ONE SYDNEY HARBOUR

STAGE 1B - Building R4B

SECTION 4.55

ARCHITECTURAL DRAWINGS

1 Bridge_Elevation North-East
1:75

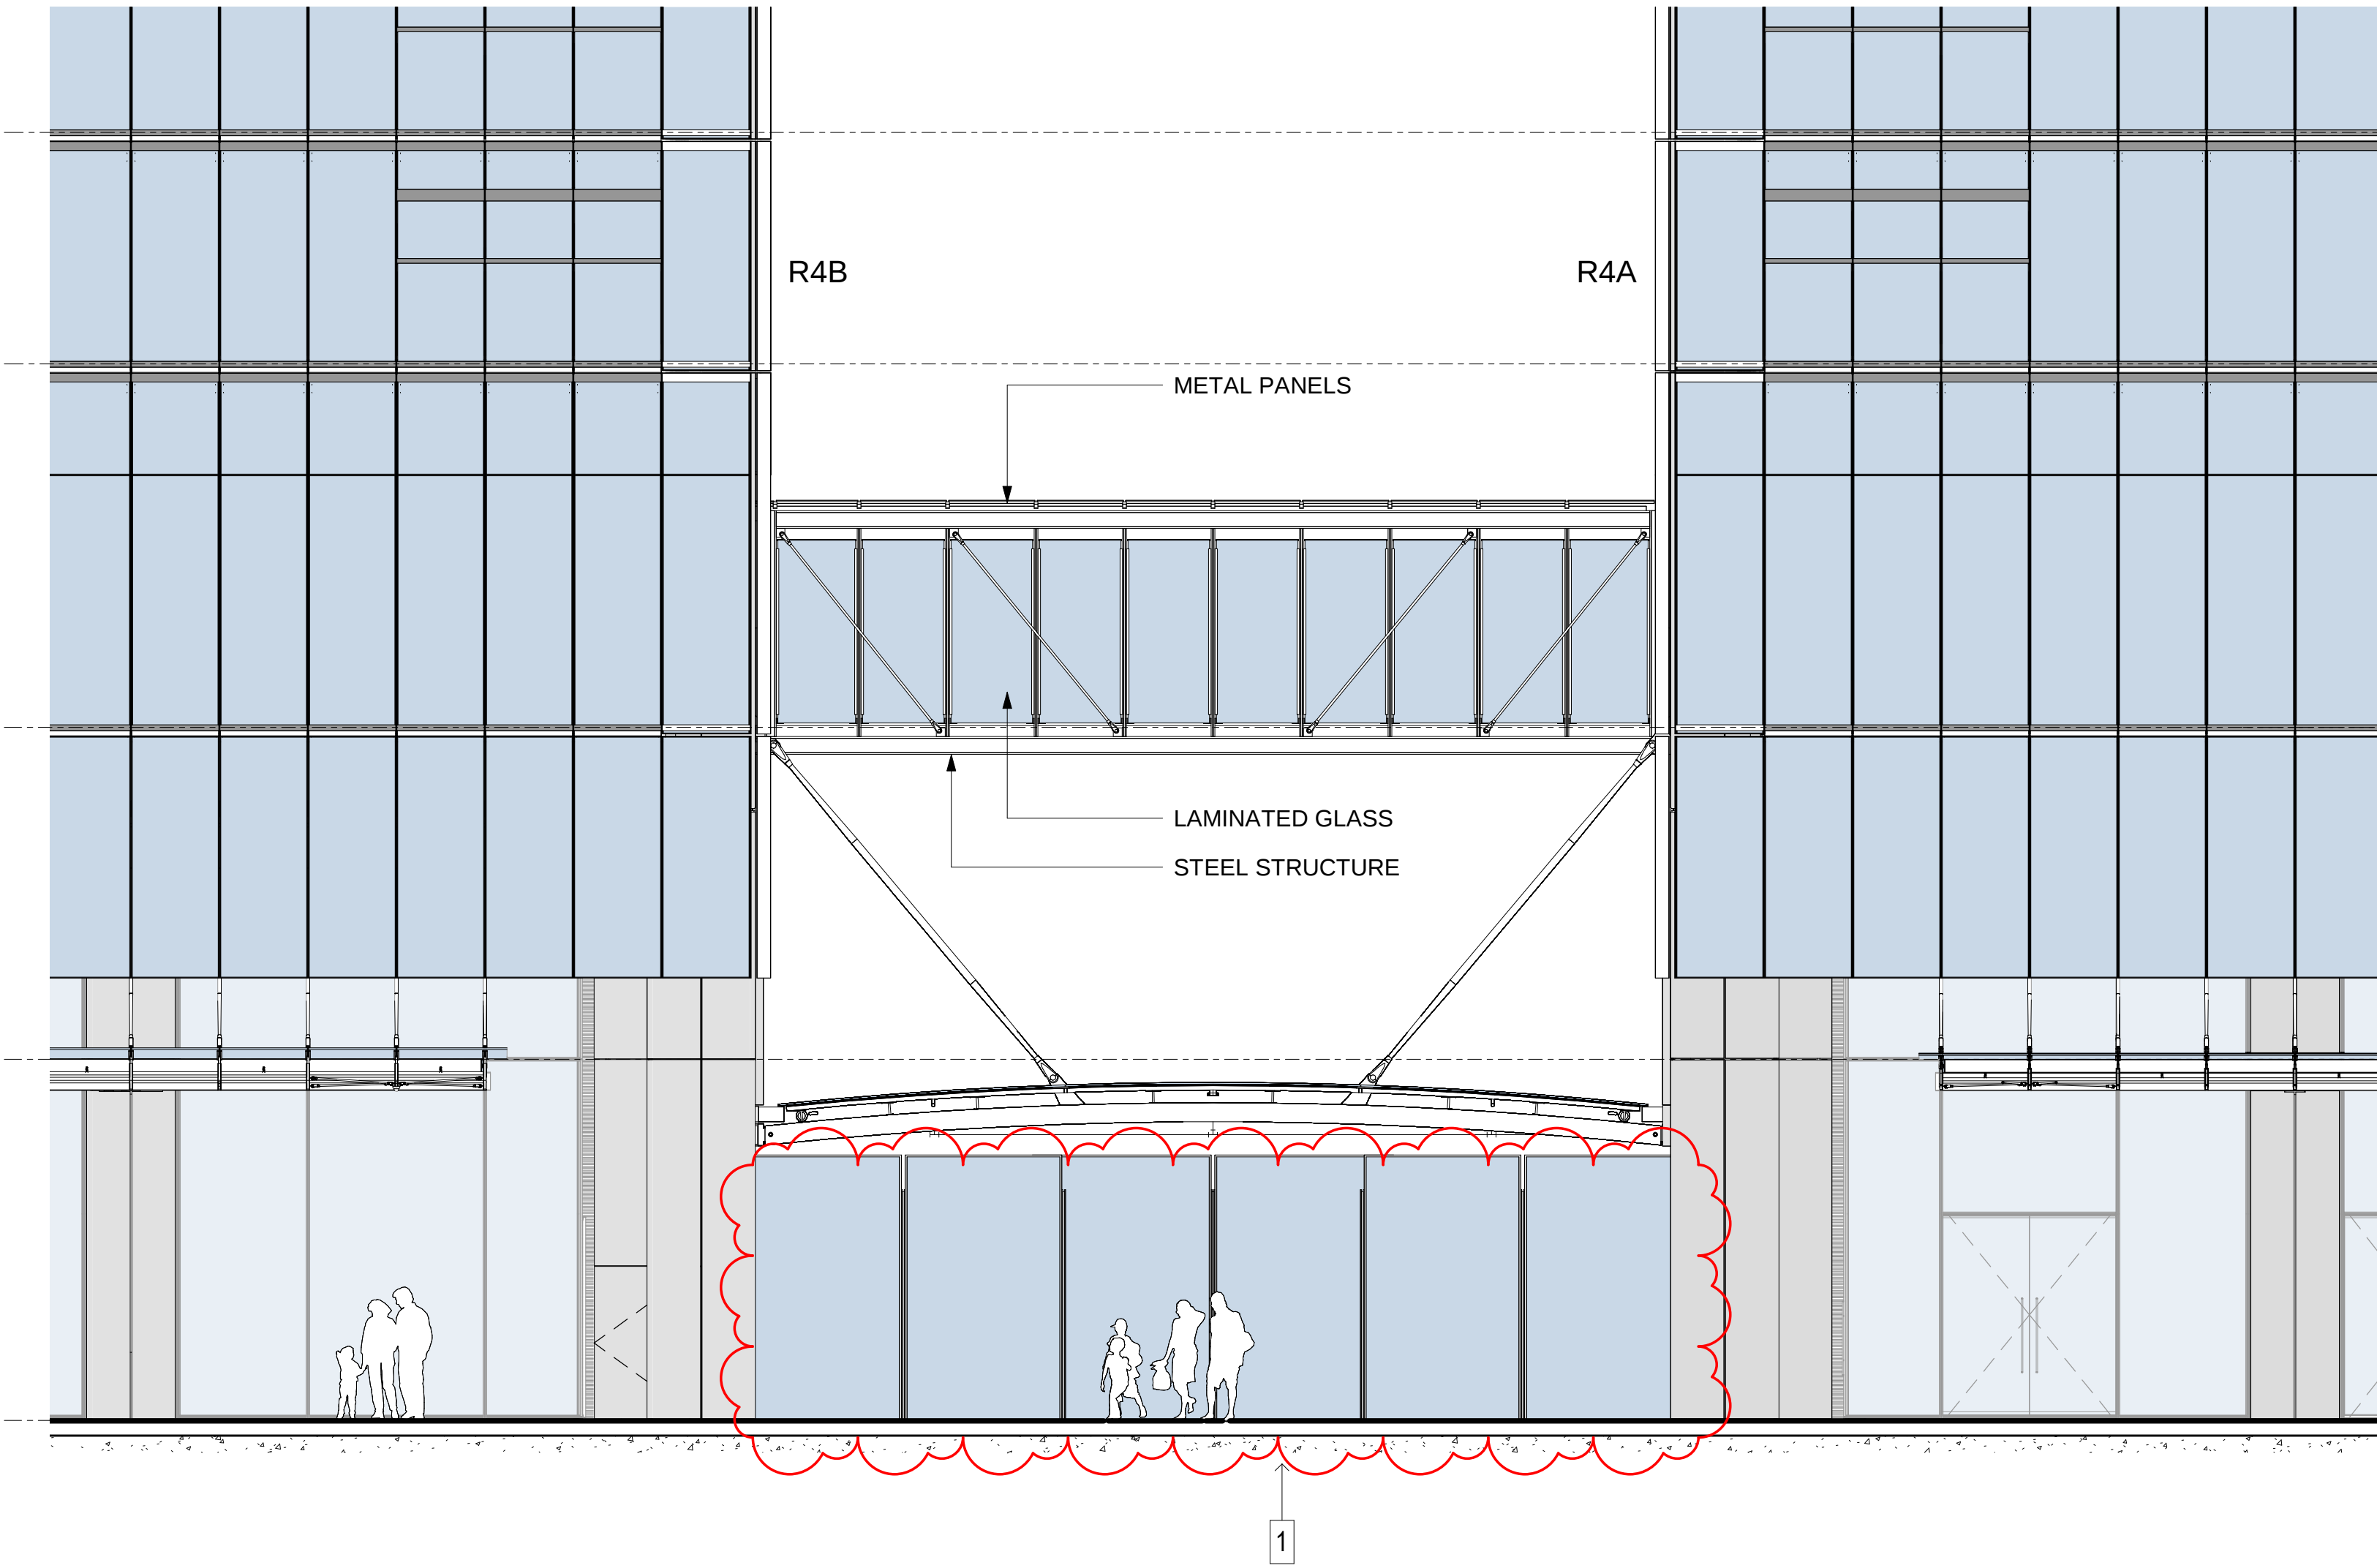
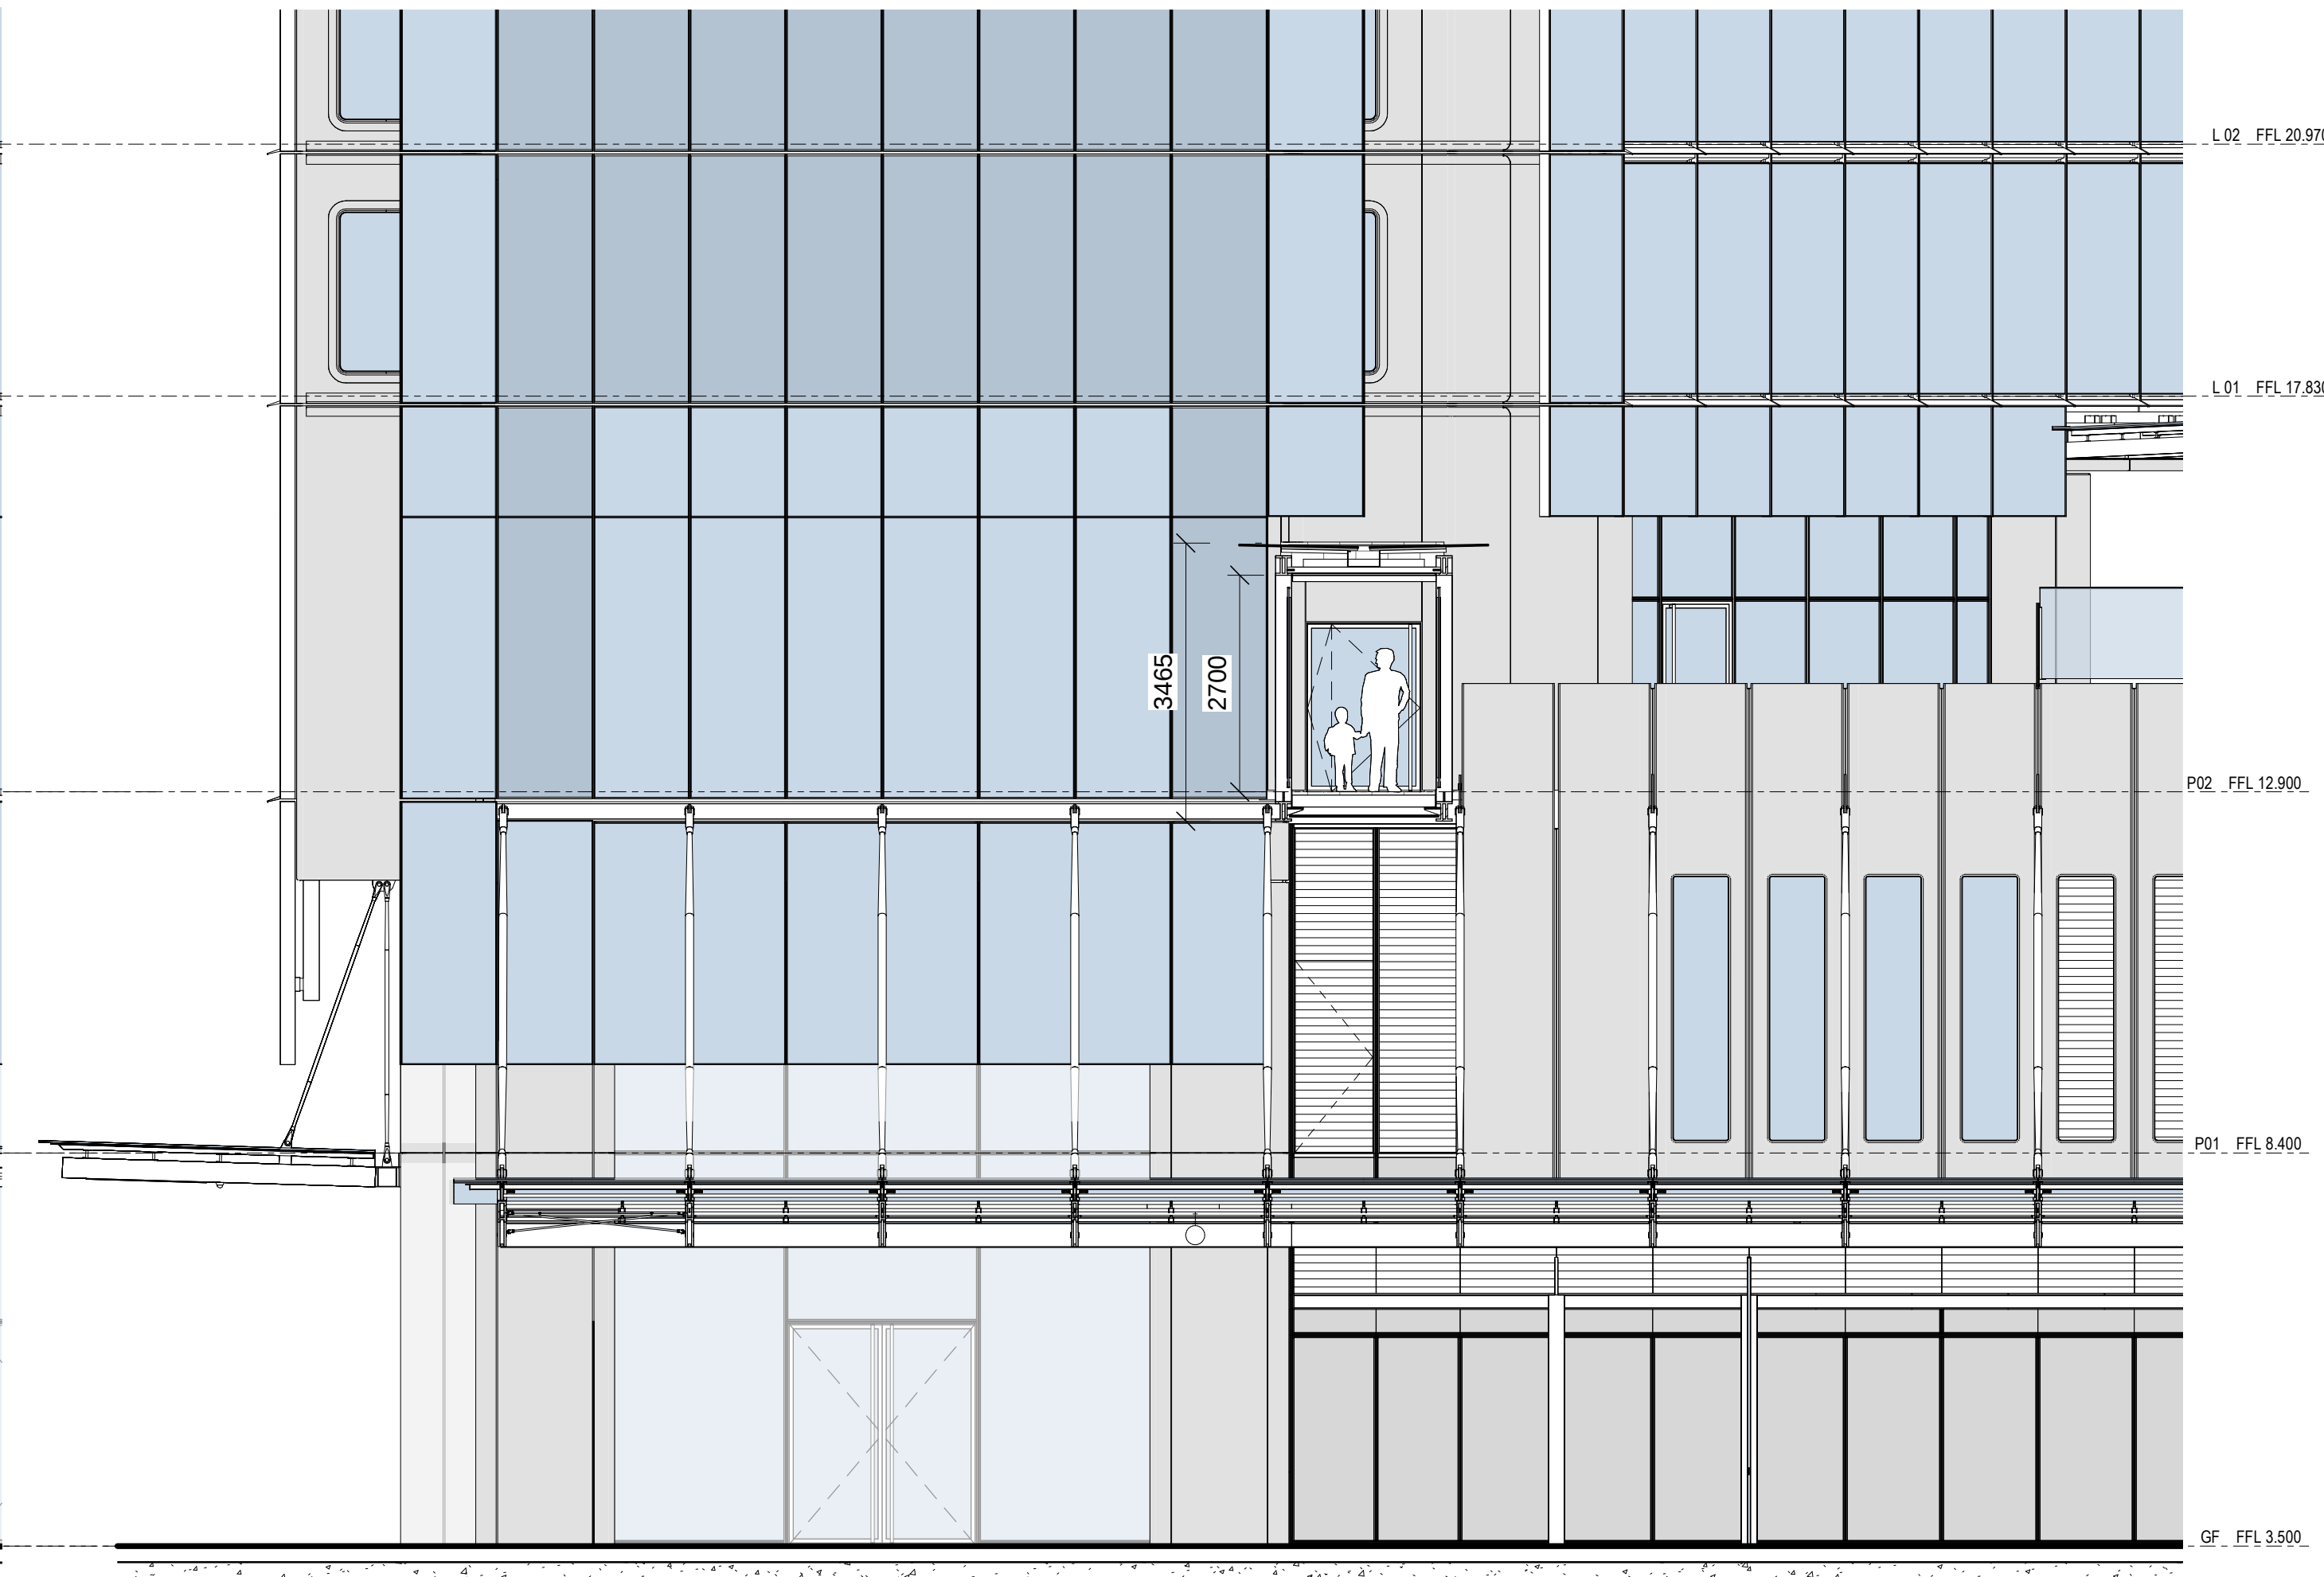
1. STRADA WIND BAFFLES PER SECRETARY APPROVAL
